H11900

## DESCRIPTIVE REPORT

# **Descriptive Report to Accompany Hydrographic Survey H11900**

## Revisions and Corrections During Office Processing and Certification

Figure 2. CUBE surface error from poor sound velocity of Survey H11901 line 304\_2130.

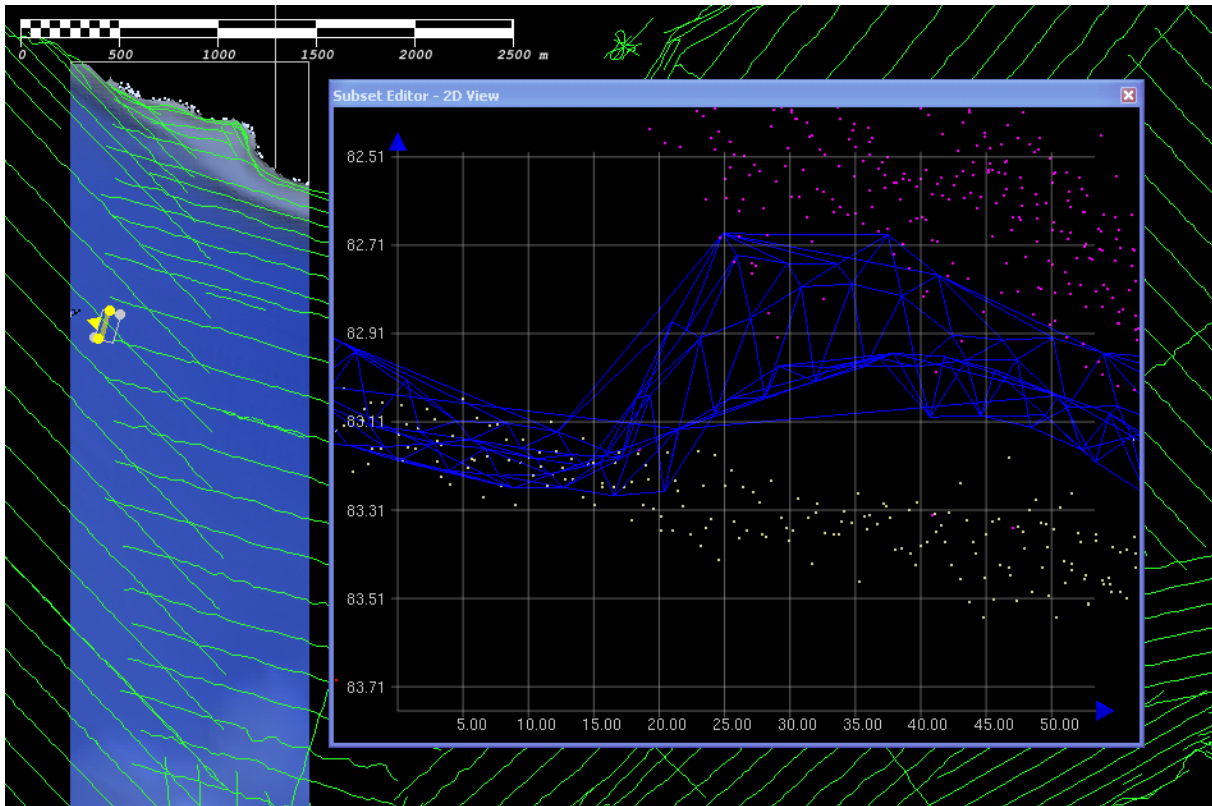
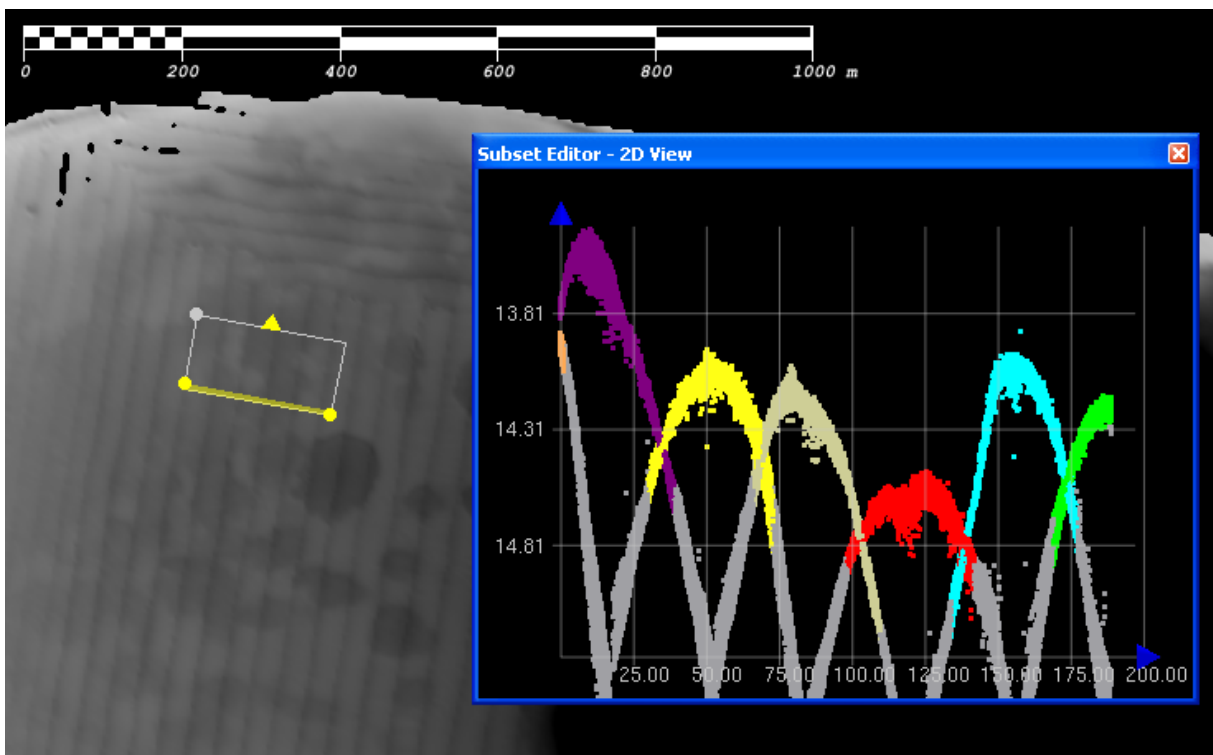
Survey H11901 line 304\_2130 showed a discernable offset of 0.6 meters at the appropriate CUBE depth resolution (see figure 2). This offset was a result of the poor sound velocity affecting the outer beams from line 304\_2130.<sup>3</sup>

<sup>3</sup> Only data from H11900 was compiled in this region of overlap between H11900 and H11901.

Figure 6. Applying the original .svp file produced egregious ‘smiles’ that exceeded IHO S-44 depth accuracy limits (left). Re-applying the ‘fixed’ cast (right), produced results within IHO S-44 standards.

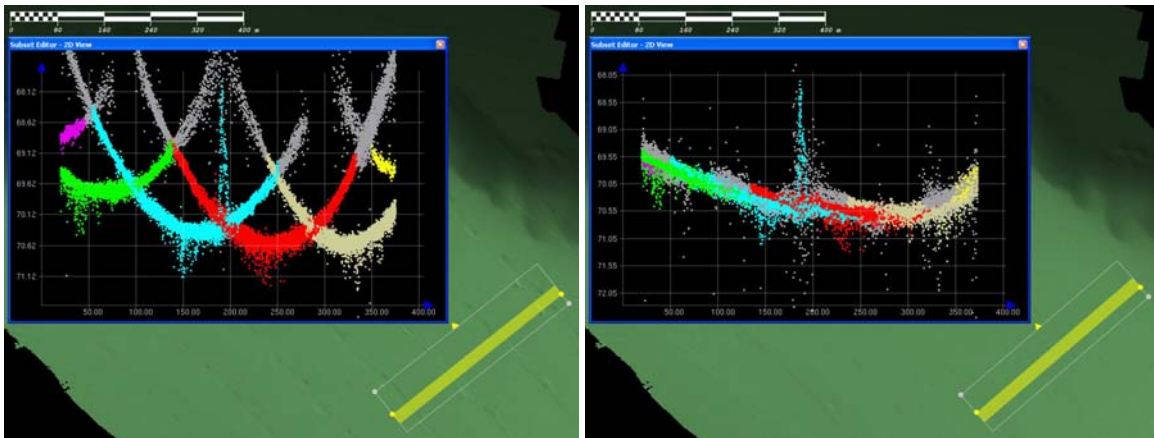
On July 9, (DN191) the cast aboard Launch 2801 (RA-5) taken at 21:45 UTC time produced curious sound velocity readings near the surface. When applied, these surface readings produced "smiles" to the bathymetry (see Figure 6), which resulted in data exceeding IHO S-44 depth accuracy limits.

The hydrographer edited the .svp file, removing the errant values believed to be skewed by the exhaust wash, and replacing the values from the 1.03 – 1.87 depth range. The result removed the "smiles" and produced more accurate bathymetry based on more accurate readings (see figure 6).<sup>4</sup>

<sup>4</sup> Despite minor deviations from data meeting IHO specifications all data are deemed acceptable and should be used to supersede prior charted data.

Figure 7. As a result of the discrepancy between the provided Lidar junction line and the actual Lidar bathymetry, holidays persisted due to the presumption of accuracy of the Lidar junction line.

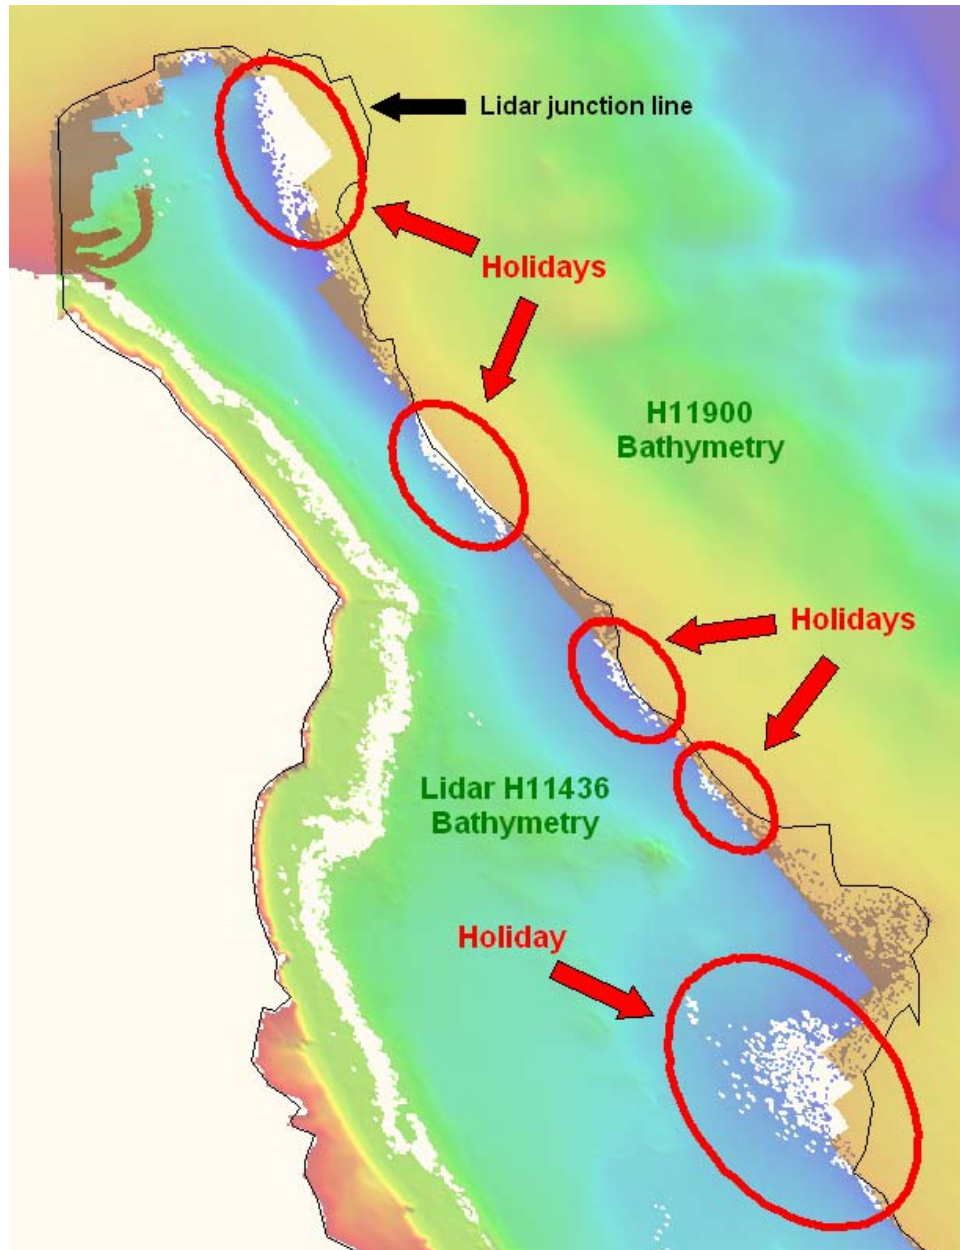
Holidays resulted from the delivery of conflicting lidar junction lines. Data planning and analysis were conducted using the Junction survey MapInfo table and not the lidar extent table delivered to the field. The discrepancy was not noted until after the field unit had left the area. (see Figure 7).<sup>5</sup>

<sup>5</sup> Given the nature of the sloping and non-rocky seafloor and examining the outer beams of the backscatter from the multibeam it was not necessary to represent these holidays in the H11900\_CS.000.

*Figure 8. Holidays are within the color purple. All other gaps in data are within the 8 meter curve and 25 meter line spacing.*

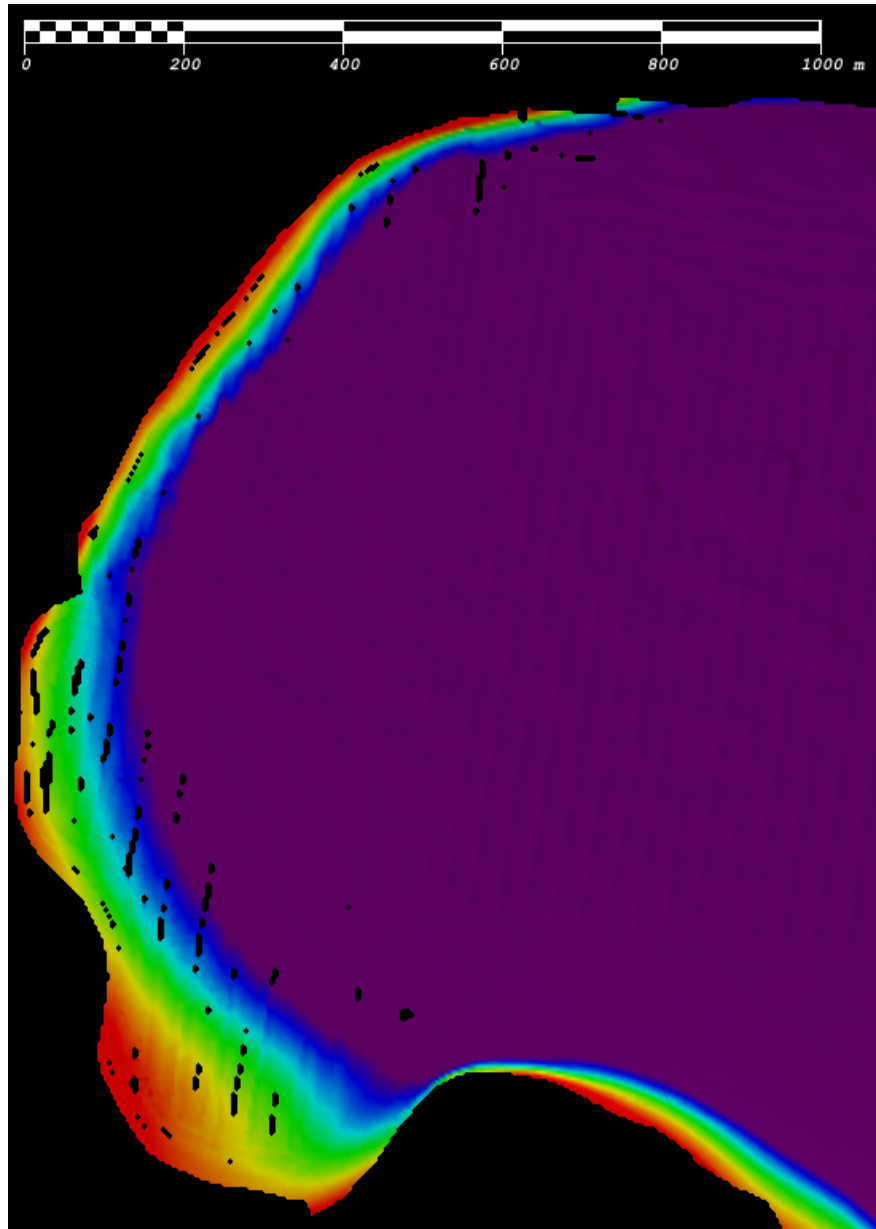
Several insignificant holidays exist seaward of the 8 meter curve in the north western area of Volcano Bay (see Figure 8). The gaps in data were a result of cleaning poor sound velocity from outer beams in the area. The outer beam data was examined prior to cleaning and no features were found. The Hydrographer recommends that survey soundings supersede all prior survey and charted depths in the common area.<sup>6</sup>

<sup>6</sup> Concur with clarification, small holidays not represented in H11900\_CS.000.

Figure 9. Left, crossline data fills a holiday that (right) exists because crossline data was not included in the creation of the CUBE surface.

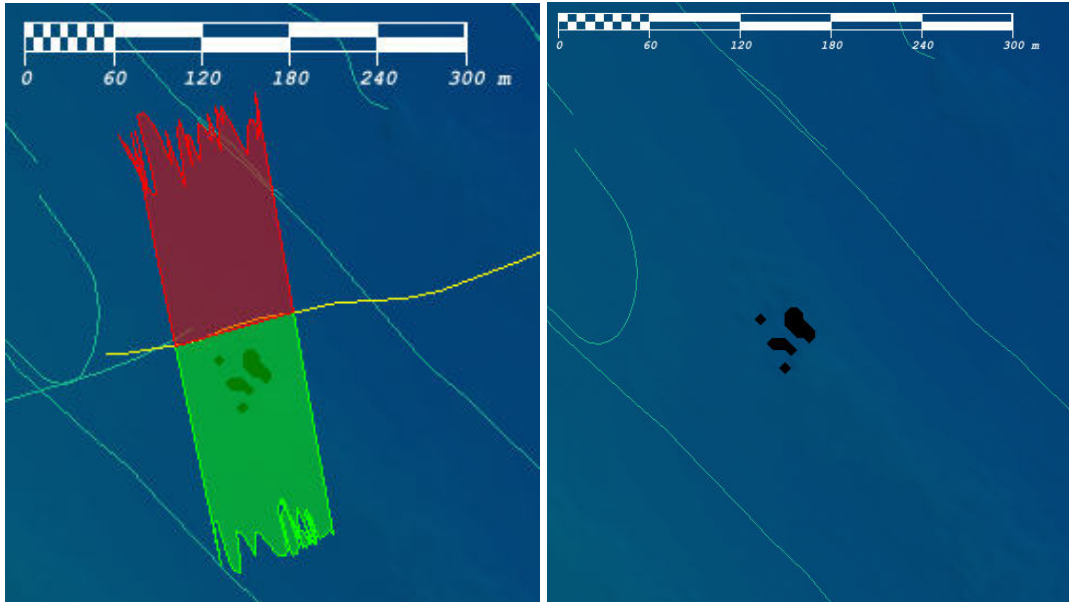
A holiday, at the north end of Volcano Bay in 68 meters of depth, was created due to the removal of crossline data (see Figure 9). All crosslines were removed from inclusion for the creation of CUBE surfaces for H11900. The majority of all crossline outer beam data exhibited poor sound velocity that, when applied to the creation of CUBE surfaces, yielded results exceeding IHO S-44 depth accuracy limits. The outer beam data of the crossline was examined prior to cleaning and no features were found.<sup>7</sup>

<sup>7</sup> Holiday not represented in H11900\_CS.000.

Figure 12: The five rocks near the western entrance of Dushkin Lagoon were not seen during shoreline verification.

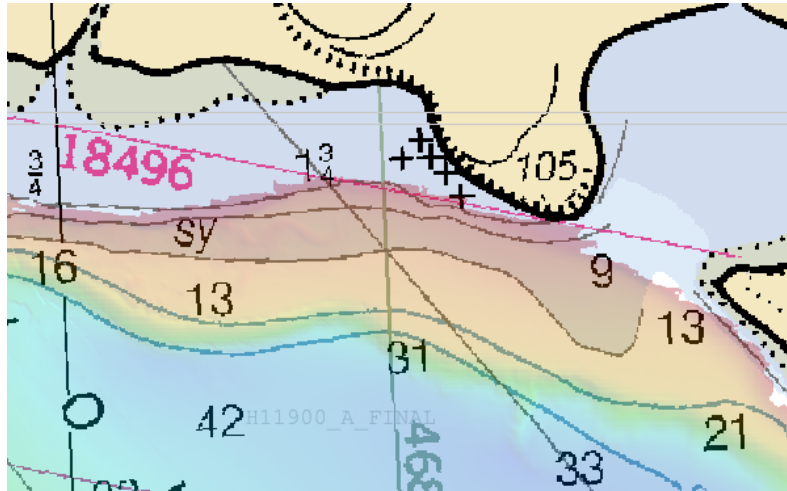
The five rocks near the west entrance of Dushkin Lagoon were not visually seen during shoreline verification. The rocks were shoreward of the inshore limit as per project instructions, therefore neither VBES or MBES techniques were feasible (see Figure 12). Because they could not be disproven, they were retained in the field verified layer.<sup>9</sup>

<sup>9</sup> Concur, blue notes have been added to H11900\_CS.000 recommending these rocks be retained as charted.

Figure 13: Numerous rocks on the western edge of Volcano bay fell within the limits of a ledge.

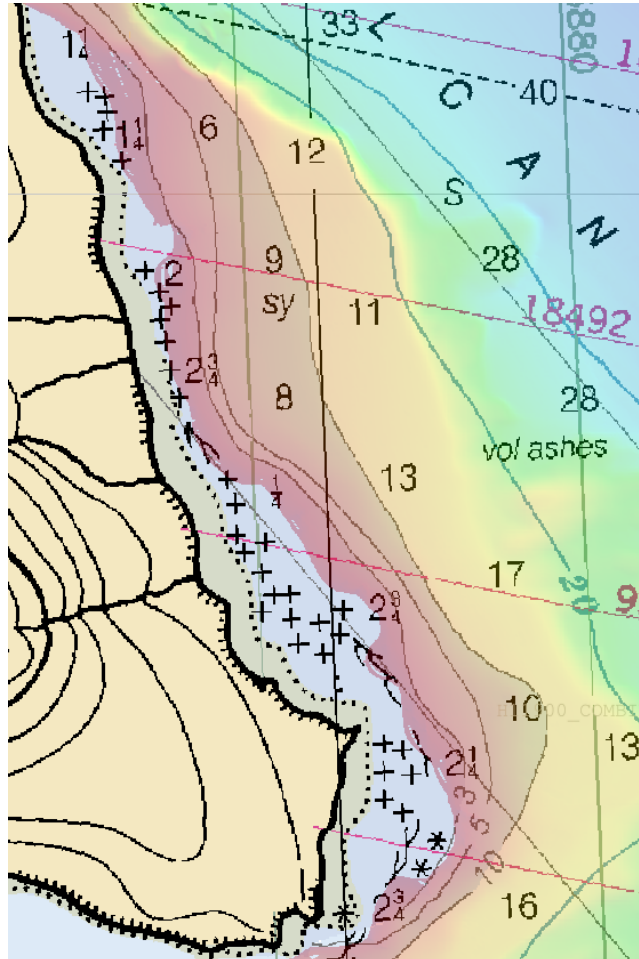
Numerous rocks charted near the western edge of Volcano Bay were actually not rocks at all; they were within the limits of a ledge. The ledge feature was created from observations in the field, and included in the H11900\_field\_verified.hob file.<sup>10</sup> (see Figure 13 and Figure 14). Some of the rocks fell between bathymetry and the ledge; those rocks were included in the field verified layer because they could not be disproven.<sup>11</sup>

<sup>11</sup> The rocks have been blue noted to be retained.

Figure 16: Two islets were not detected (left); the hydrographer recommends deleting and replacing the islet with the Lidar sourced land areas (right, circled red) shown in the composite source.

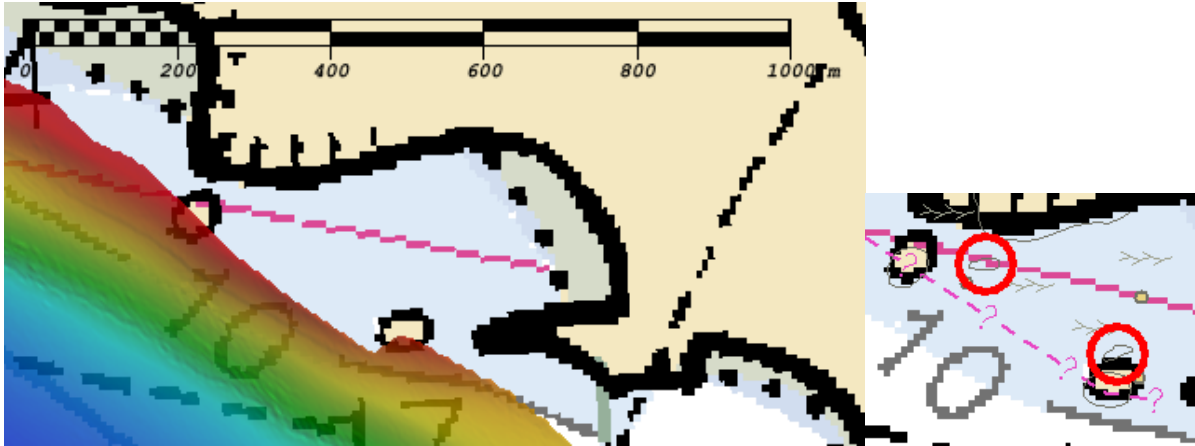
Southeast of the entrance to Dushkin Lagoon, near the far northeast limit of survey H11900, two charted (16549) islets were not detected; the hydrographer recommends deleting them from the chart (see figure 16). The composite source layer shows land areas inshore of the islets. Recommend charting land areas as per lidar data.<sup>13</sup>

<sup>13</sup> Concur with clarification; updated GC shoreline was applied to the new edition of the chart. Islands are correctly charted on the new 16<sup>th</sup> edition of the chart.

Figure 17: A pronounced rock, one meter in height, amongst a rocky area.

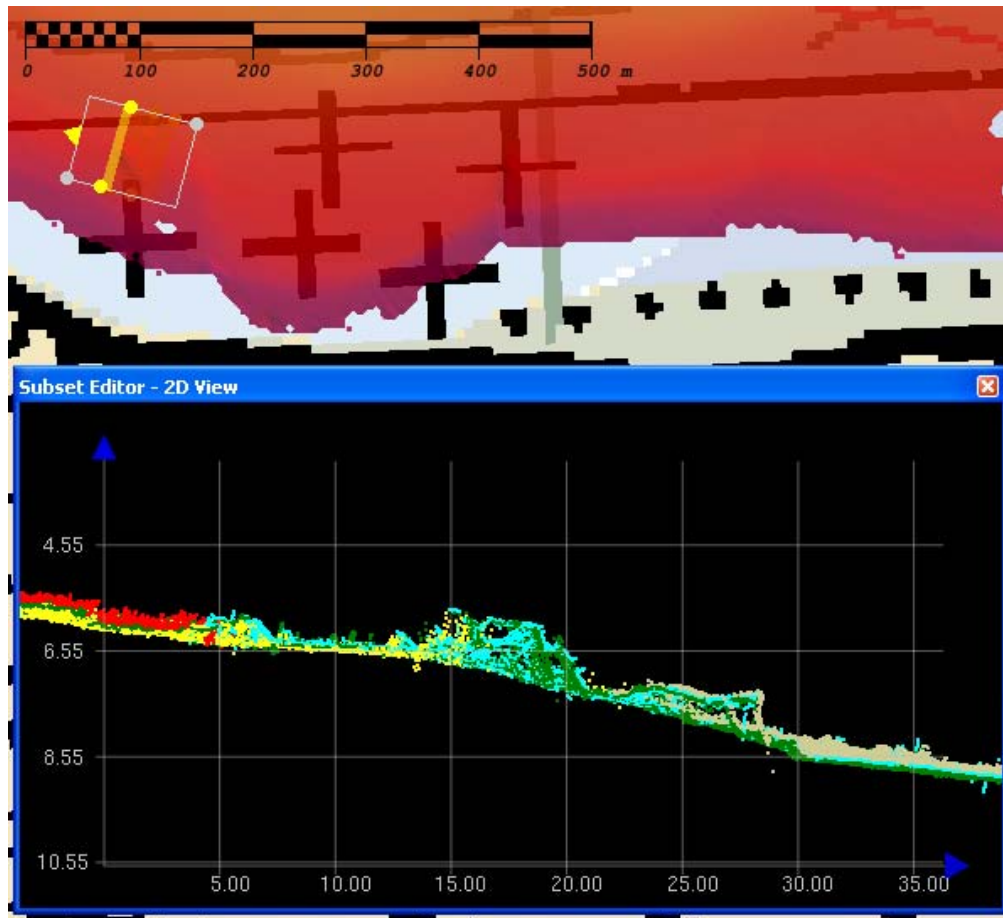
In addition, a rocky feature one meter tall was identified near the five charted rocks discussed above (see figure 17). The feature is within a rocky area on a slope. A rocky area, encompassing this feature, was added to the field verified layer.<sup>17</sup>

<sup>17</sup> Rocky seabed areas delineated by the field were determined to be to inappropriately small for the scale of chart 16549, regardless all shoal depths have been selected for charting, and some portrayed as rocks.

Figure 18: Two rocks (circled) were disproved by multibeam data.

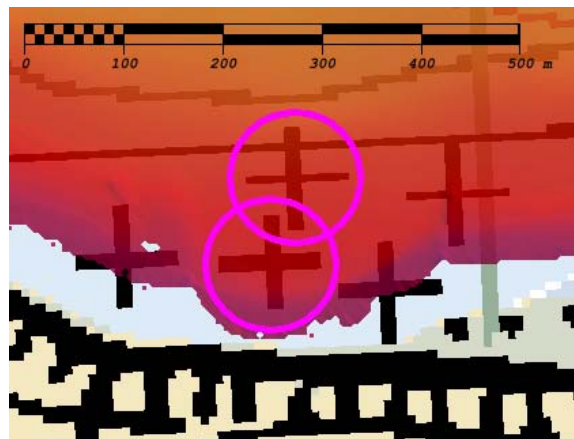
There were two charted rocks disproven in multibeam bathymetry near the southern entrance of Bear Bay (see figure 18). These rocks were removed to the deleted source layer.<sup>15</sup>

<sup>15</sup> The rocks disproved by multibeam have been flagged for removal via bluenotes.

Figure 23: The entrance to Bear Bay exhibits noticeable difference between charted depths and soundings. The 2 ¼ depth (left) is nearly 9 fathoms shoaler than MBES bathymetry.

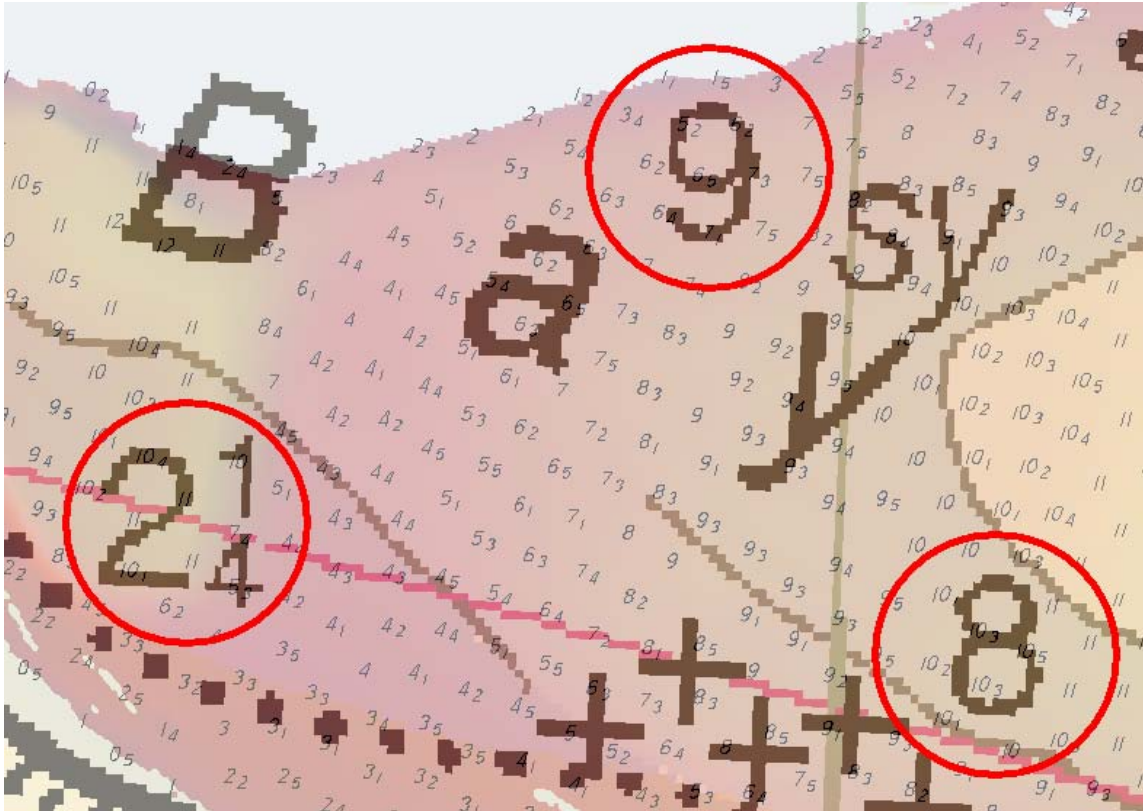
Soundings from survey H11900 were generally within one to two fathoms of depths on chart 16549. In areas where the charted depth and soundings were greater than 2 fathoms, there was no noticeable trend in shoaling or deepening (see Figure 22). The entrance to Bear Bay exhibited the most pronounced differences, with variances of up to 9 fathoms (see Figure 23).

The Hydrographer recommends that survey soundings supersede all prior survey and charted depths in the common area.<sup>18</sup>

<sup>18</sup> Concur.
